## HISTORIC AND DESIGN REVIEW COMMISSION

### Agenda Item No: 22

**HDRC CASE NO:** 2016-180  
**ADDRESS:** 3220 MISSION RD  
**LEGAL DESCRIPTION:** NCB 7659 BLK LOT 4E  
**ZONING:** MF33 H  
**CITY COUNCIL DIST.:** 3  
**DISTRICT:** Mission Historic District  
**APPLICANT:** EJ Lee/Maia Investments, LLC  
**OWNER:** Maia Investments, LLC  
**TYPE OF WORK:** Window replacement, Exterior Modifications  
**REQUEST:**

The applicant is requesting a Certificate of Appropriateness for approval to:

REMODEL ELEVATIONS  
EJ LEE  
3220 MISSION ST  
SAN ANTONIO, TX  
78214

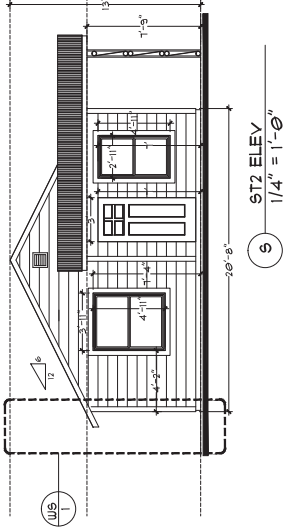
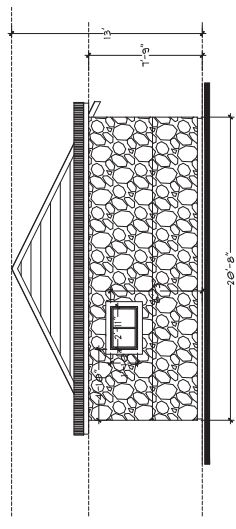
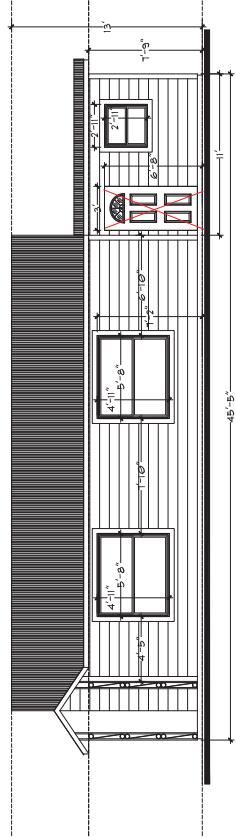
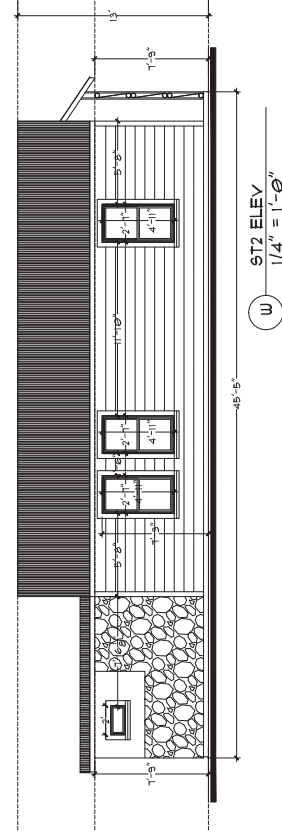
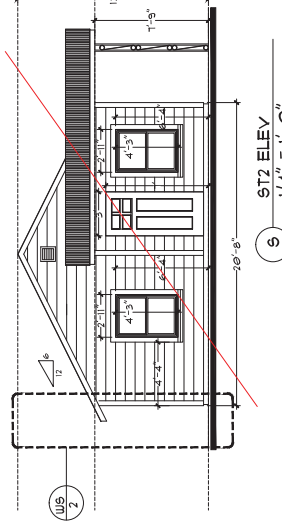
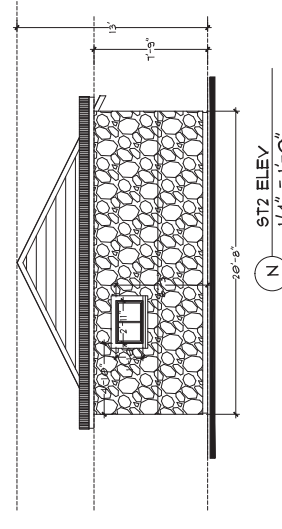
- ① put "+" divider
- ② put ledge underneath of the glass
- ③ This door is made with composite wood and laminate coated

AFTER - WINDOW 1, D2, 2

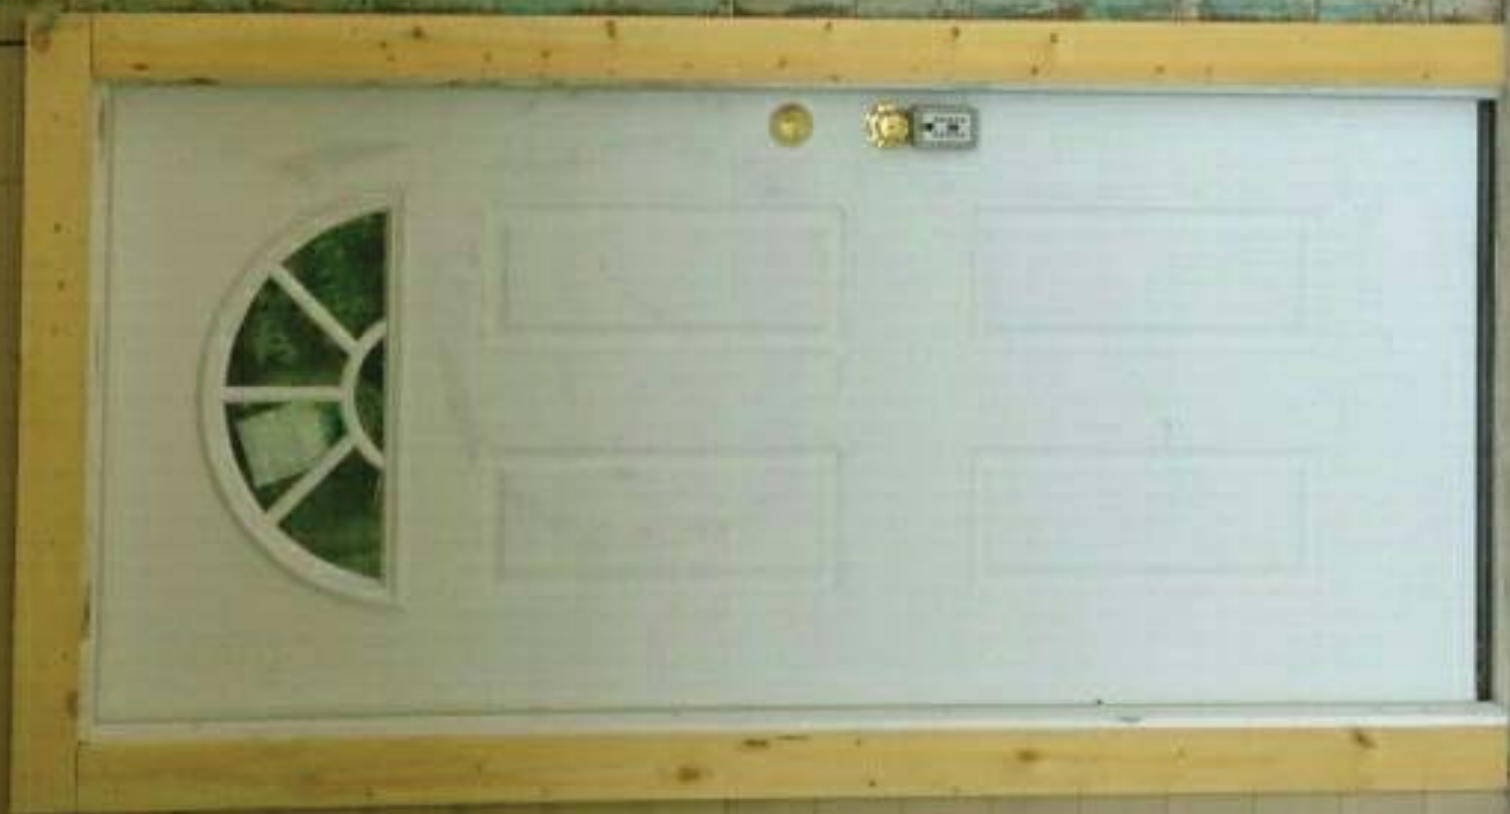
- m. The applicant is proposing to replace 2 steel casement windows with one aluminum one over one windows. According to the Guidelines for Exterior Maintenance and Alterations 6.B.vii., historic windows should be repaired or, if beyond 50% deteriorated, should be replaced with a window to match the original in terms of size, type, configuration, material and details, feature clear glass, and recessed within the window frame. Staff finds the proposal not consistent with the Guidelines. Staff recommends that windows that were historically installed be re-installed, or replace with steel casement windows.

historically installed be re-installed, or replaced in-kind, whether steel casement or wood, that the two side doors be made of wood, and that the replacement windows be made of historically appropriate material, like wood or steel.

BEFORE/AFTER - WINDOW 6

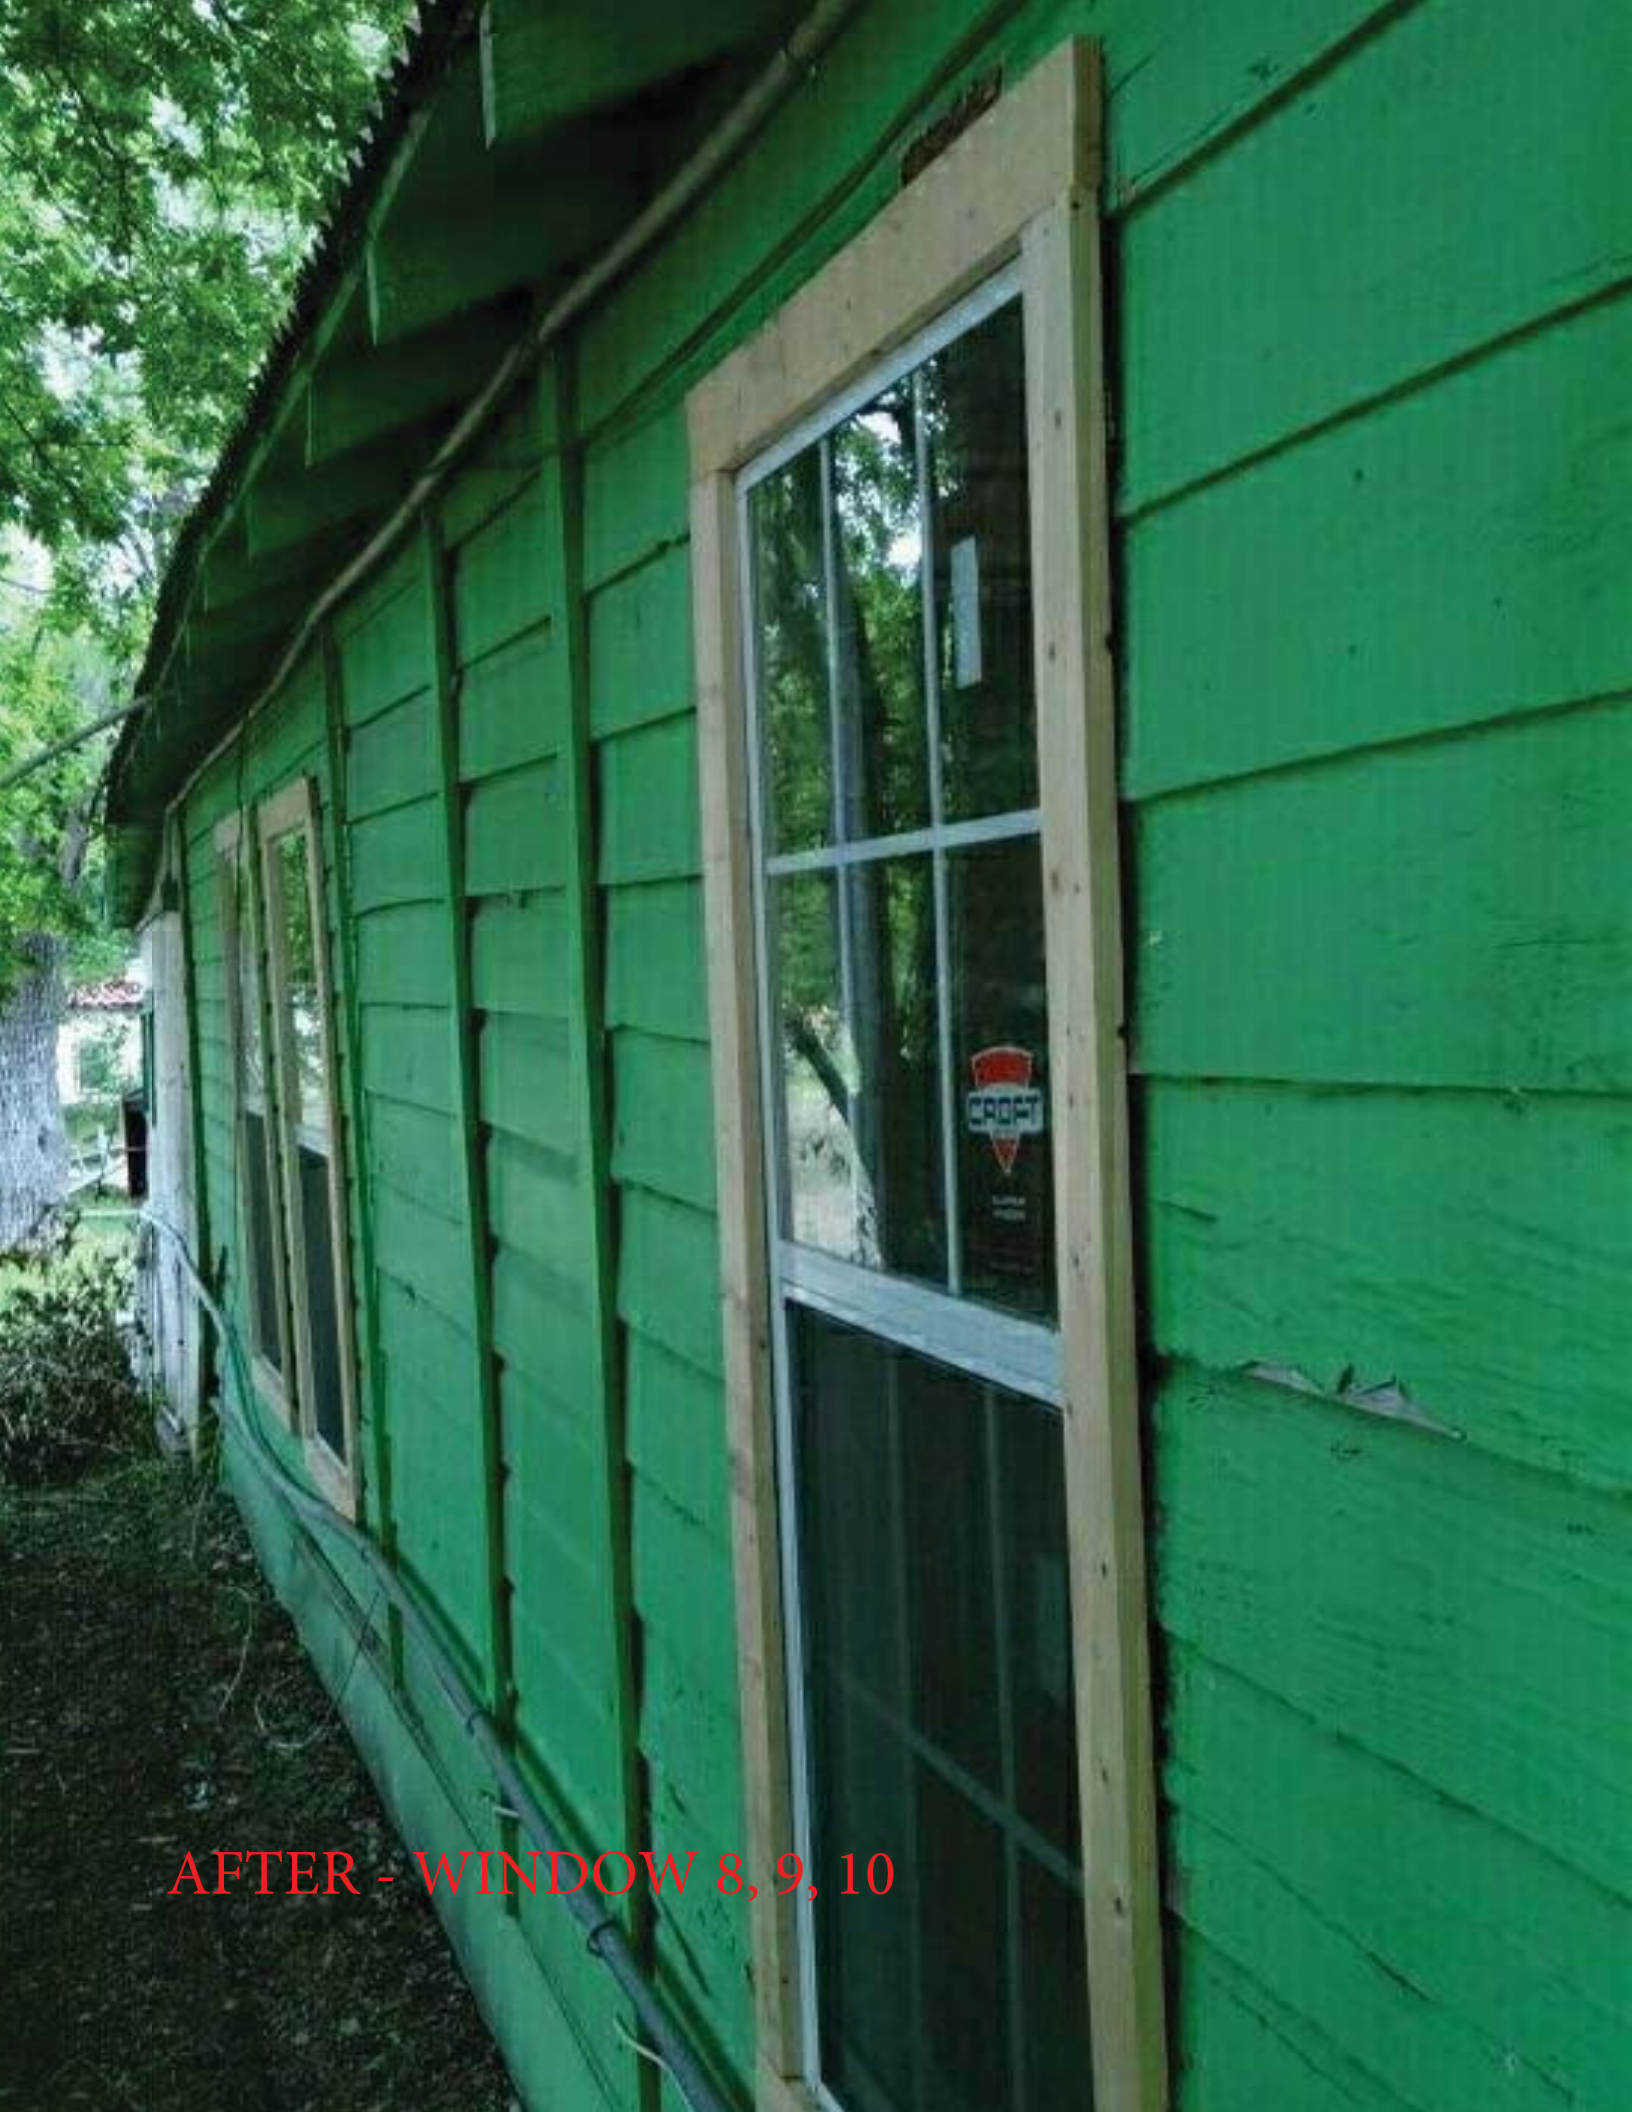
- l. The applicant is proposing to replace 8 aluminum with new one over one aluminum windows inset 2 inches. According to the Guidelines for Exterior Maintenance and Alterations 6.B., non-historic windows should be replaced with windows that are typical of the architectural style of the building. Staff finds that wood windows or steel casement windows are typical of the craftsman style home. The corresponding pages from the adopted windows policy document have been added to the exhibits for this request. Staff finds the proposed windows not consistent with the Guidelines. Staff recommends the windows be made of wood, and match the proportions of the existing wood windows.
